Report number: 202508054

KCDC PROPOSED PRIVATE PLAN CHANGE 4

65 and 73 Ratanui Road, Paraparaumu: Ecological Assessment Response

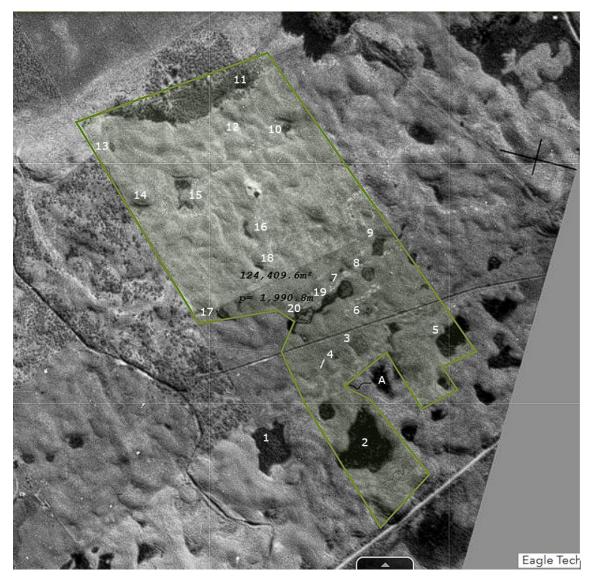
The description of the Site (Keesing 2024) is generally accurate except for Wetland 2 and Wetland 17 (**Figure 2**). The Ecological Assessment finds that the 'stormwater pond' (aka Wetland 2) and Wetland 17 are artificial ponds and are therefore not considered further.

However, these ponds are visible in aerial photographs dated from the 1940s onwards⁴ and even the shapes are relatively unmodified. As can be seen from **Figure 3** all off the wetland features identified by Keesing (2024) were also visible in the aerial photograph from the 1940's. Thus, it seems more likely that these two ponds (2 and 17) are natural inland wetlands rather than constructed wetlands. It may well be that they have been further modified by human intervention, but they appear to be natural inland wetlands under the NPS-FM.

Further evidence needs to be provided by the applicant to support the assertion that these are 'constructed ponds'. The wetlands indicated on "DEV3- Figure 1: Ratanui Development Area Structure Plan" are indicative based on the information of potential wetland loss in the ecological assessment (Keesing 2024). The quantum of wetland offset area needs to be appropriate to the quantum of natural inland wetland lost (to adhere to matters set out in the NPS-FM and NES-F). If Wetland 2 and Wetland 17 are found to be a natural inland wetlands, rather than constructed, then the wetland offset area may need to be greater than currently indicated in **Figure 1**.
